PIC16F62X Silicon/Data Sheet Errata

The PIC16F62X (Rev. A) parts you have received conform functionally to the Device Data Sheet (DS40300B), except for the anomalies described below.

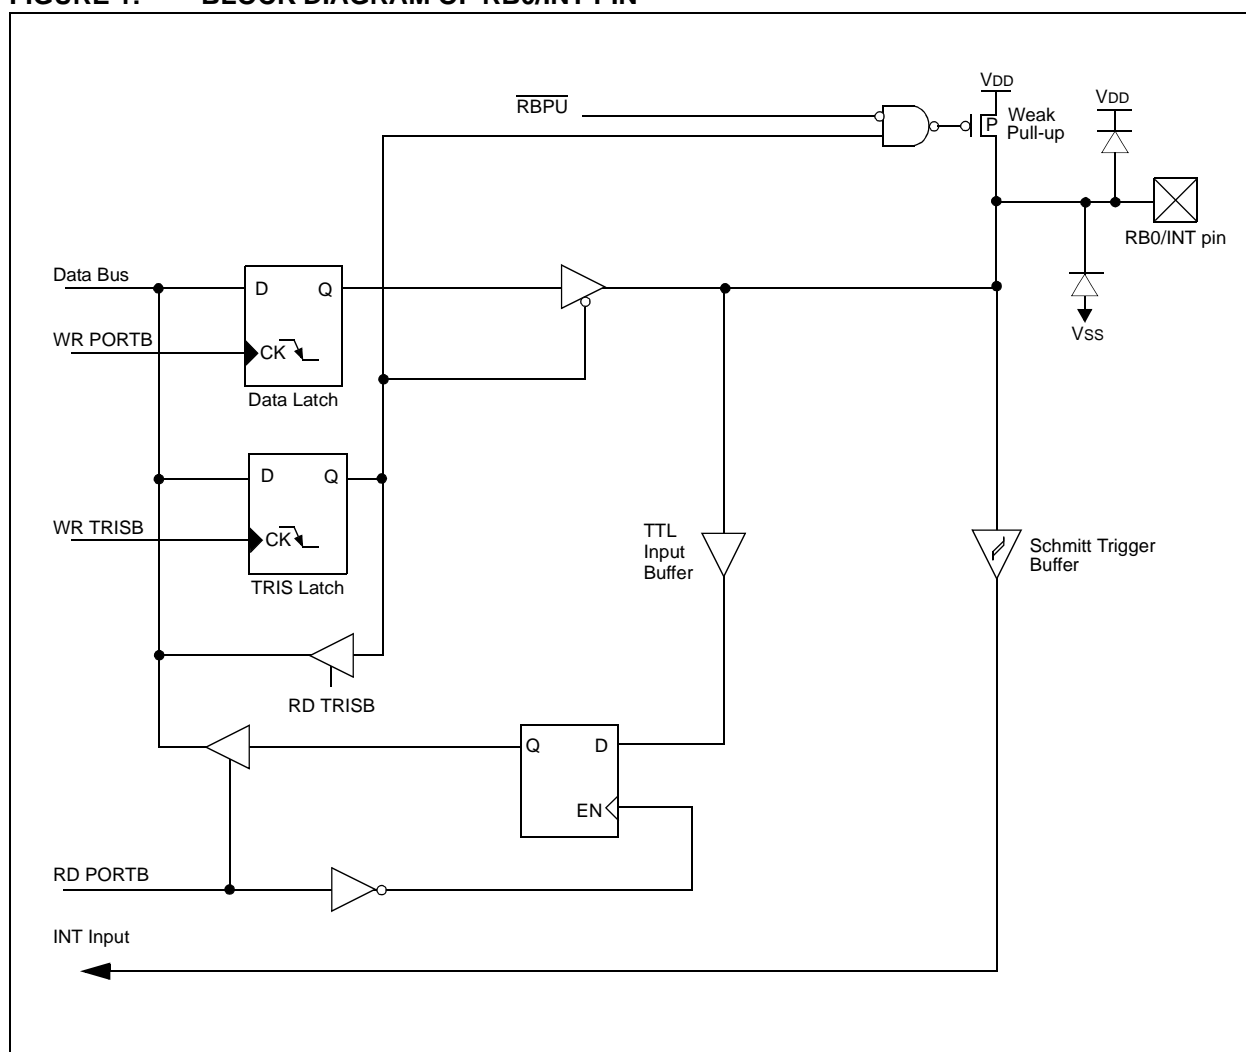
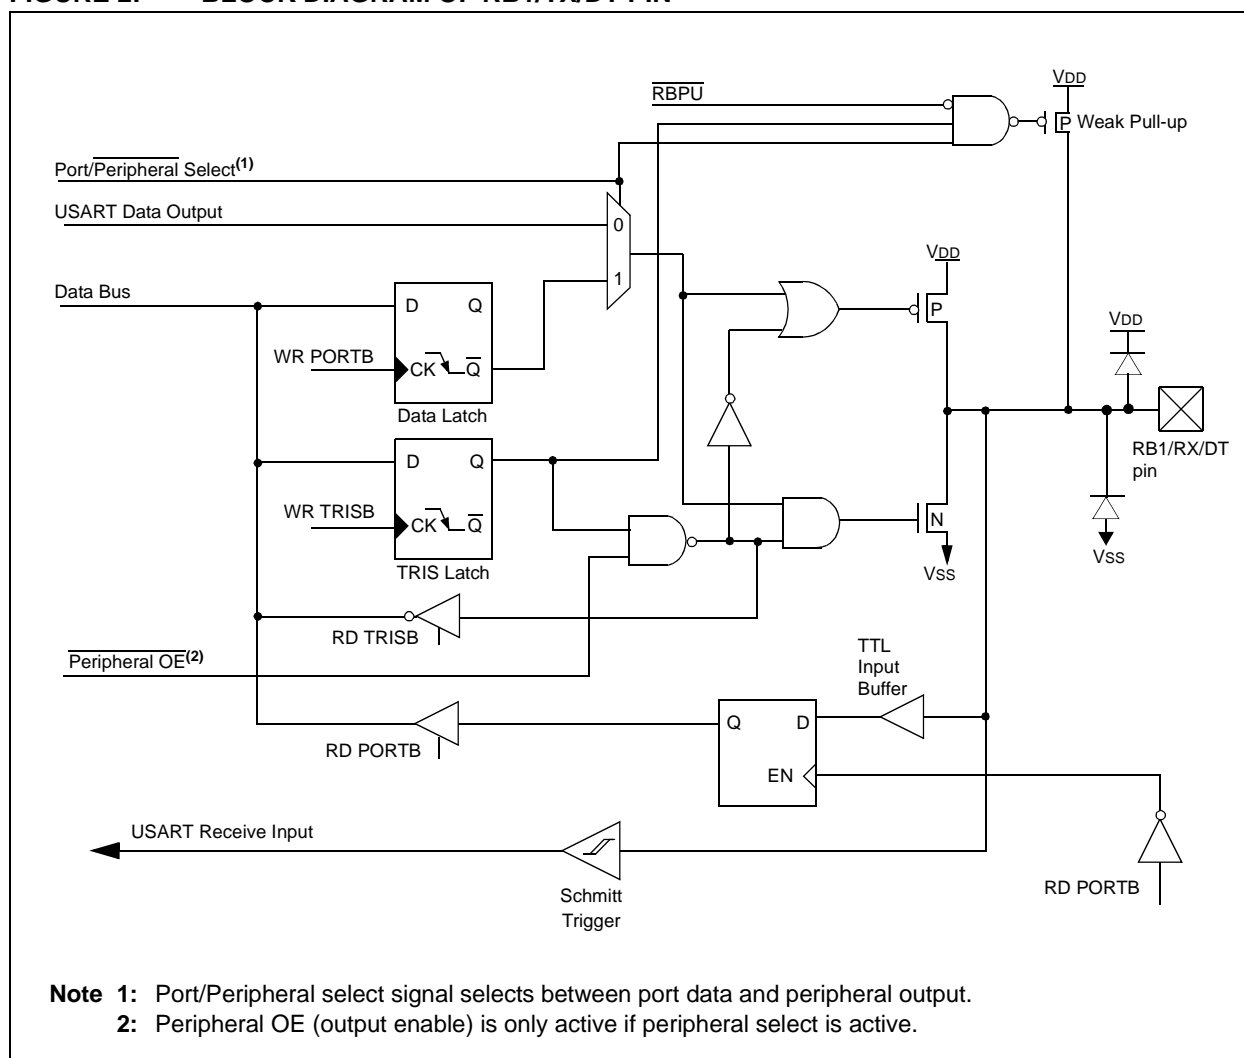
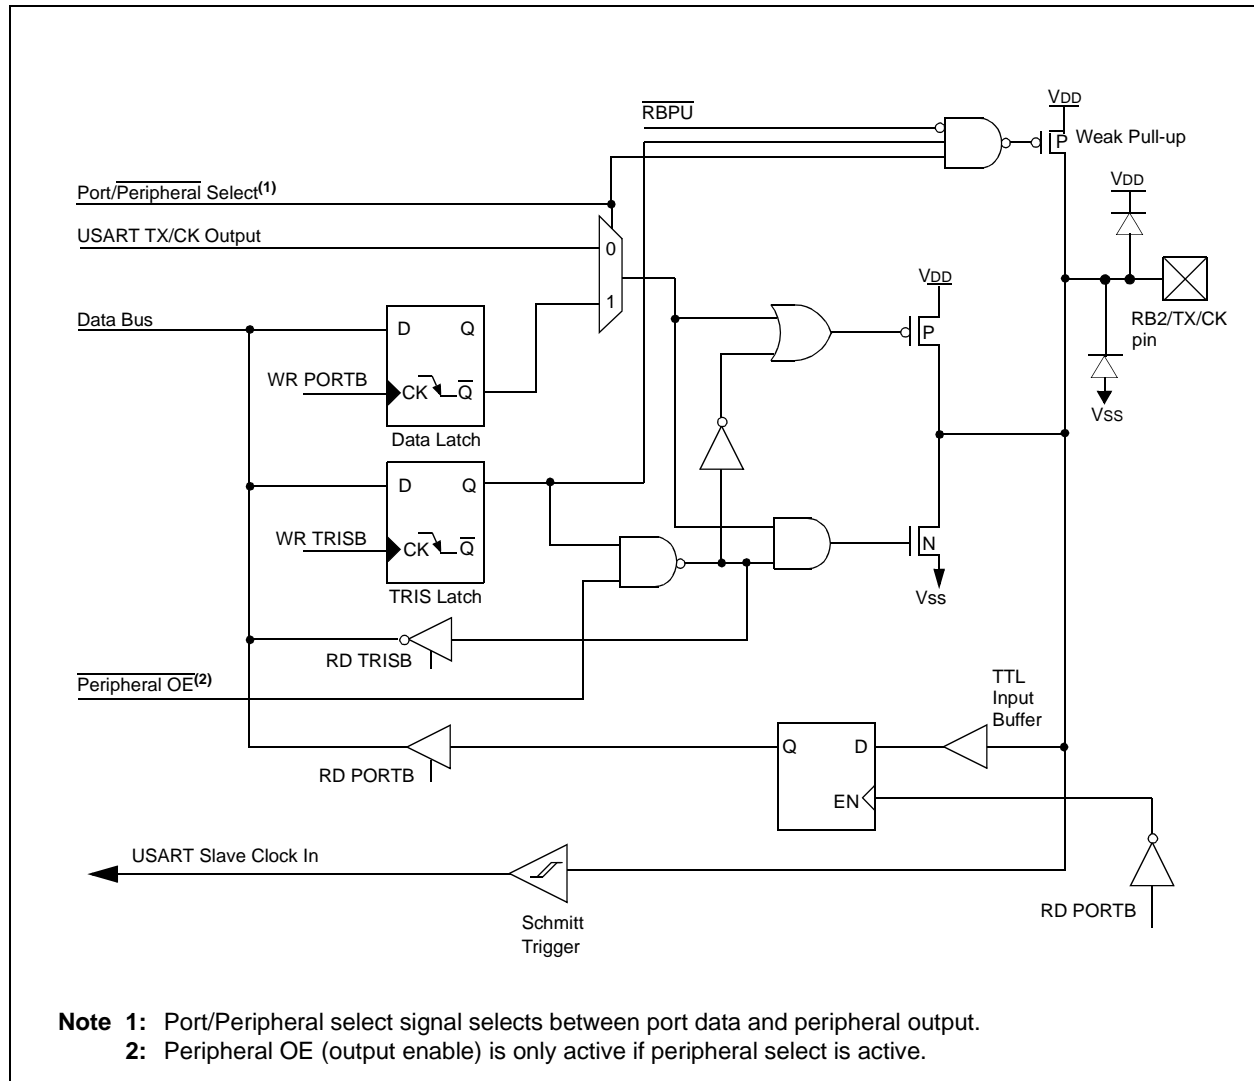
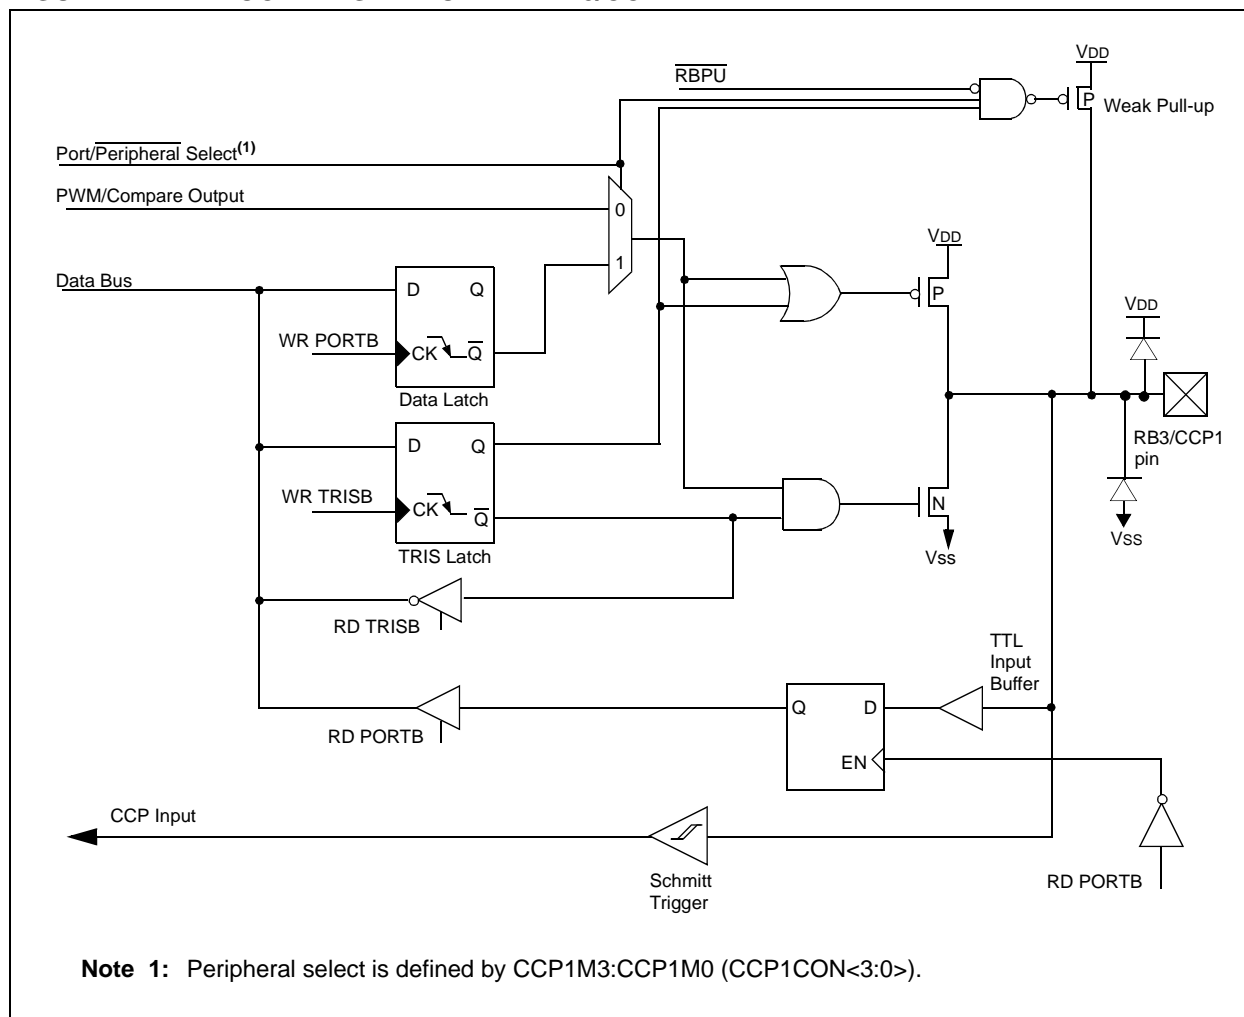
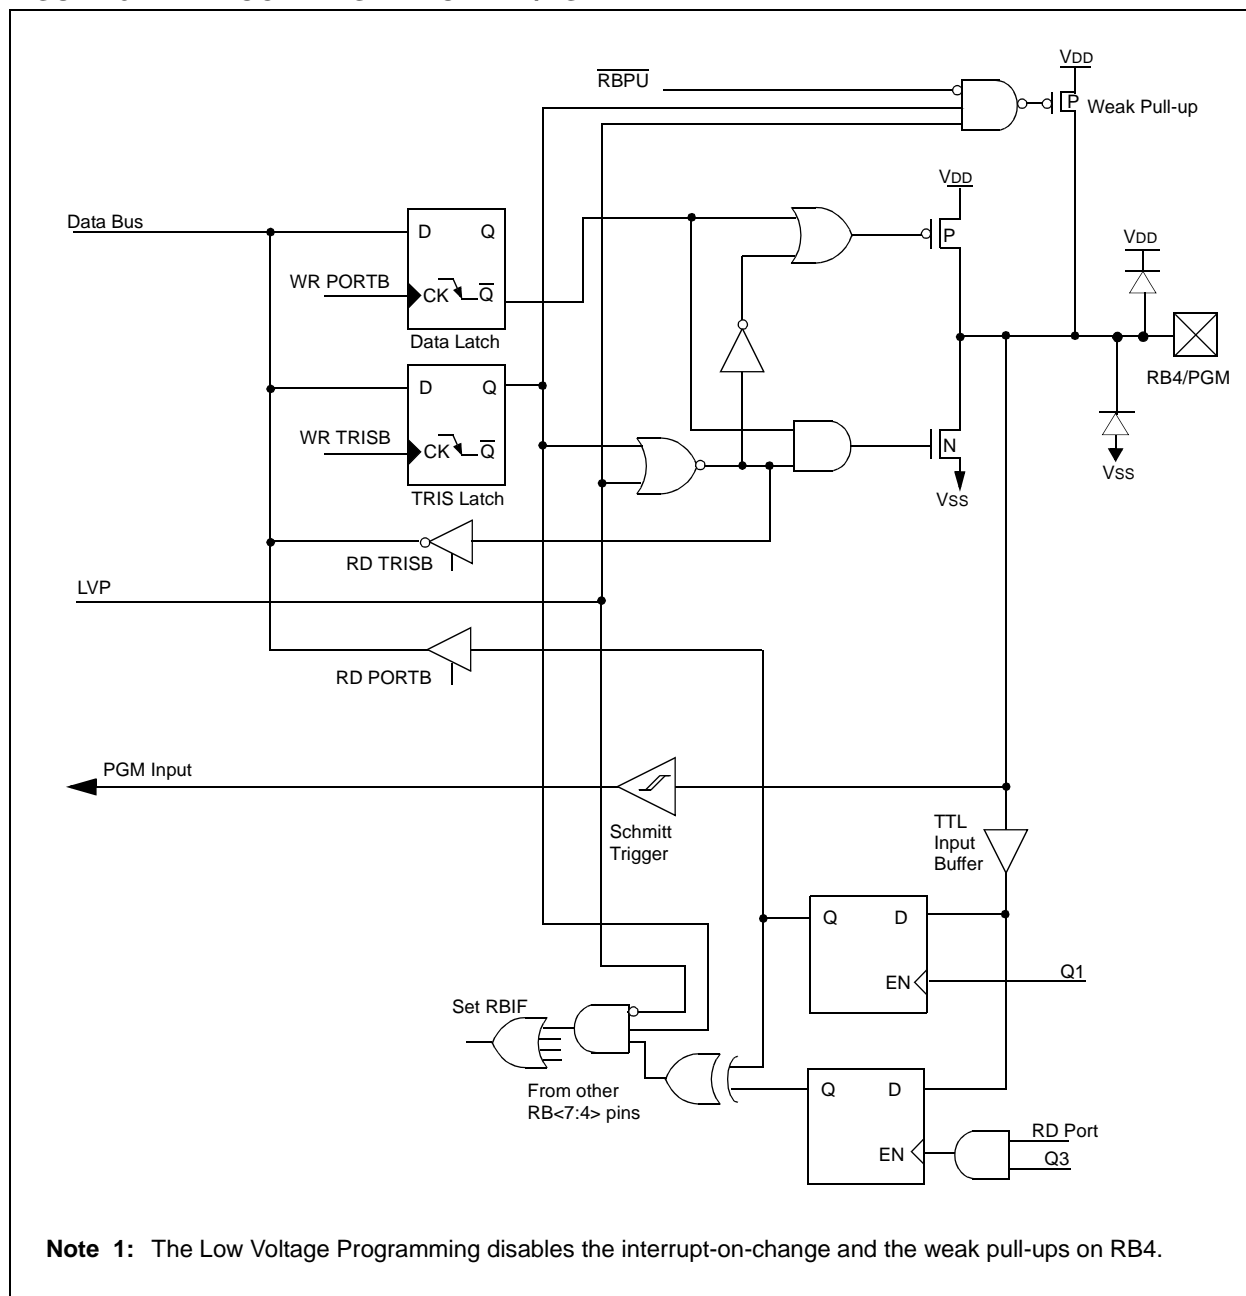
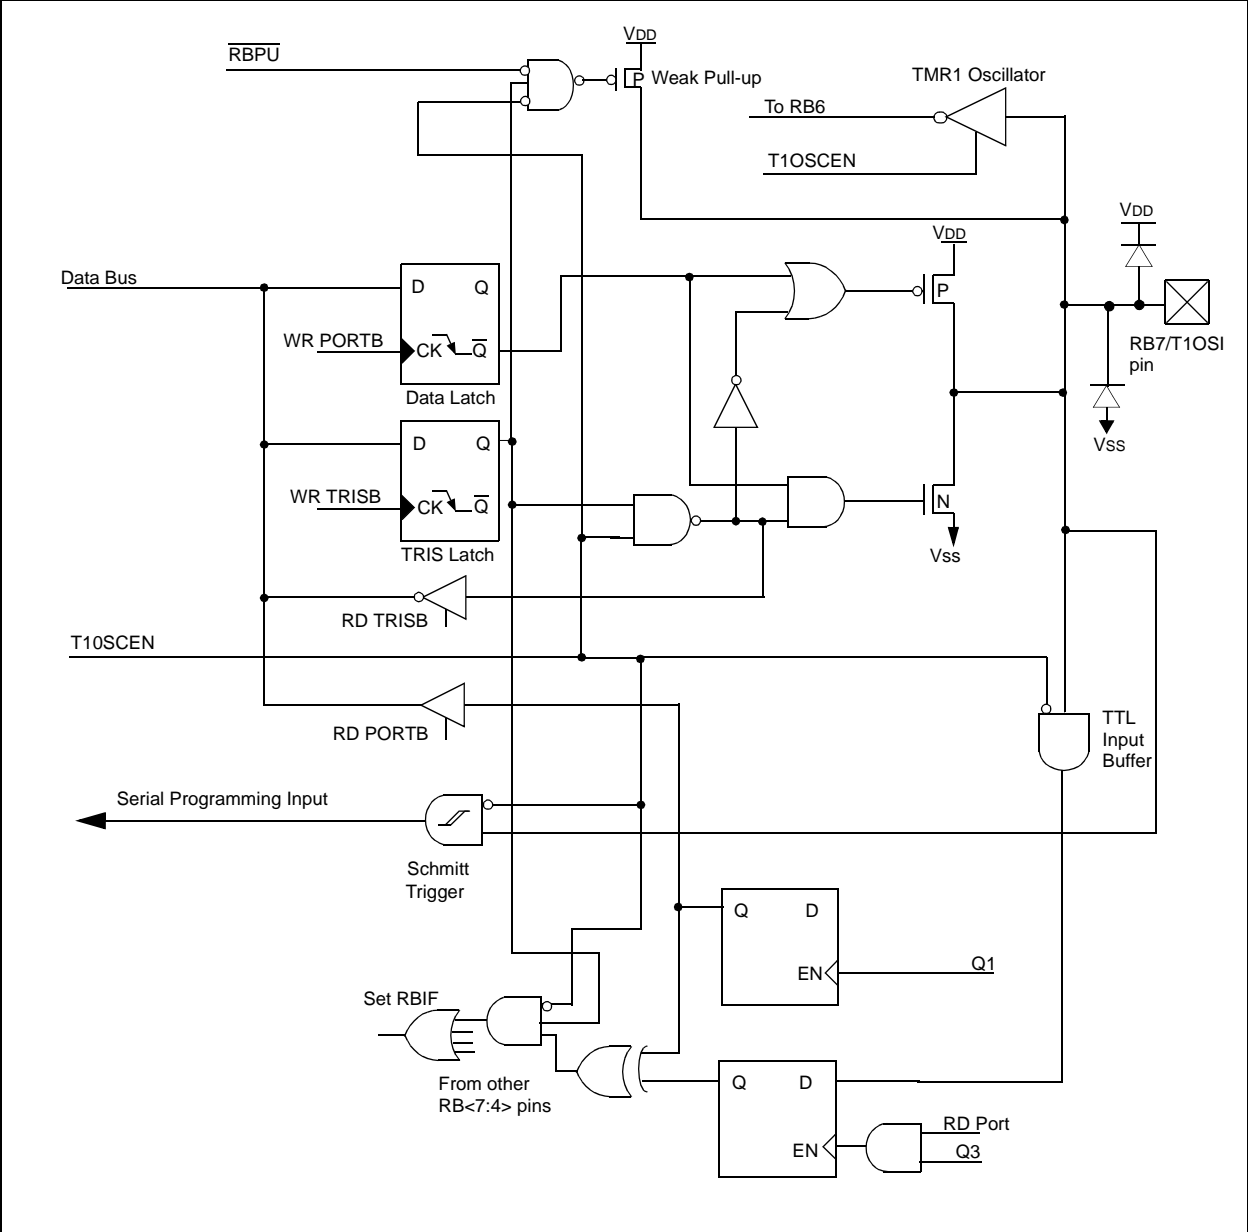
A read of the PORTB Data Direction Register (TRISB) returns the Data Direction state on the port pins themselves and not the contents of the TRISB register latch.

FIGURE 5-5: BLOCK DIAGRAM OF THE RA5/MCLR/VPP PIN

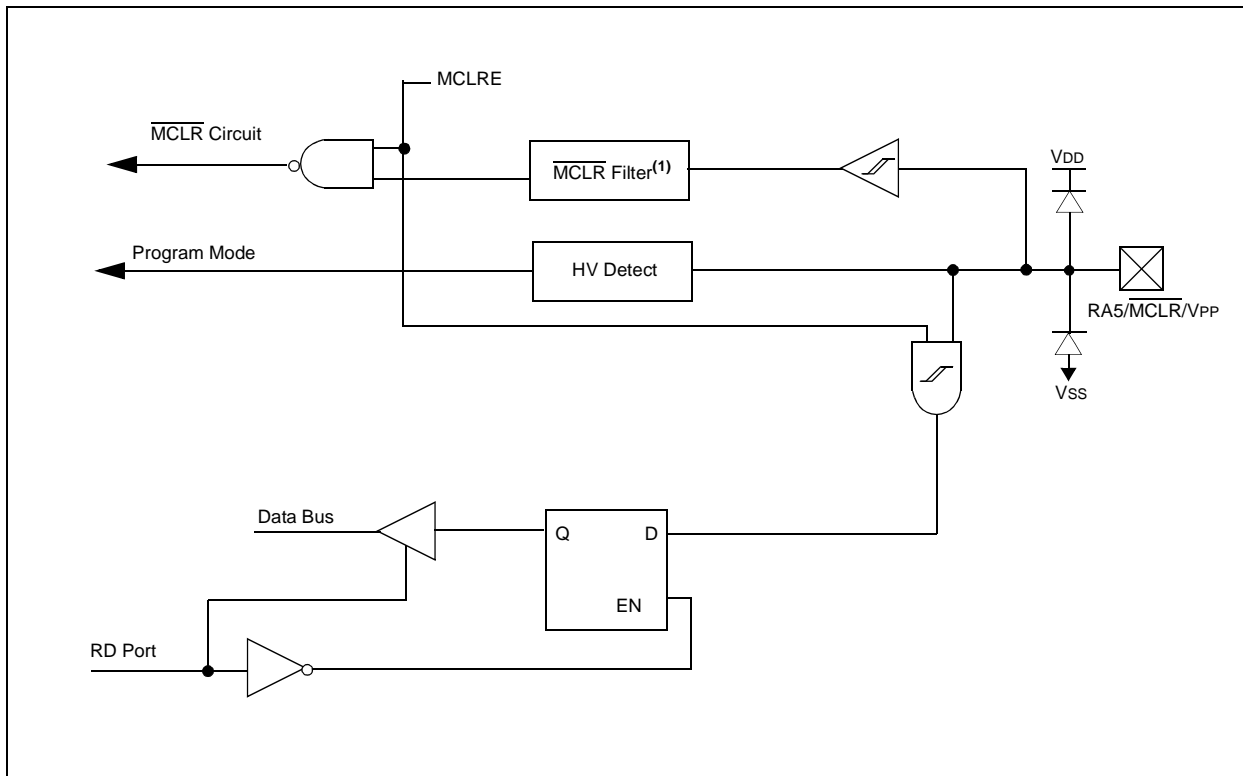
The following block diagram shown in Section 5, Figure 5-5 is incorrect. The following figure should be used instead.
